AMENDMENTS TO THE DRAWINGS

Application No. 10/029,973  
Applicant: Jeong Ho LEE et al.  
Title: CHECK VALVE  
Responsive to Official Communication dated: May 6, 2003

FIG. 1  
RELATED ART

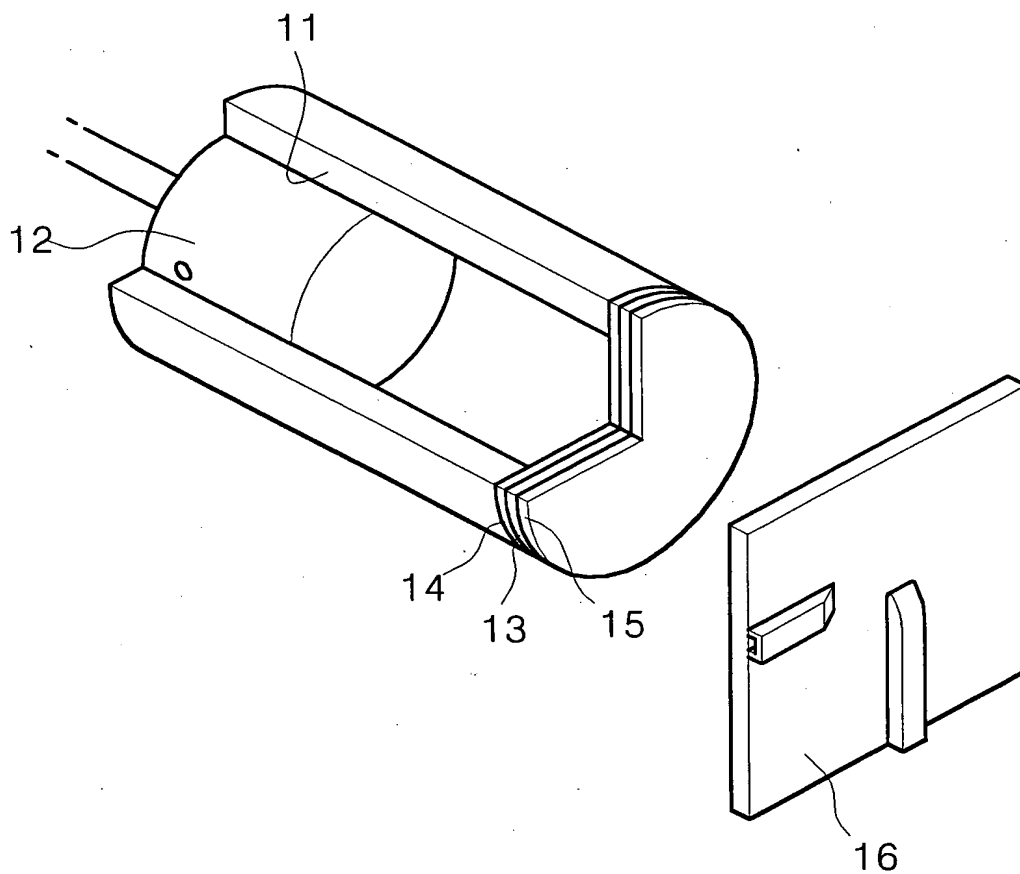
Please replace the three original sheets of drawings containing Figures 1, 2A-2D, 3A and 3B with the three replacement sheets of drawings attached hereto. In the three replacement sheets of drawings, Figures 1, 2A-2D, 3A and 3B have been labeled as "RELATED ART".

Not approved  
RK  
11/04/03
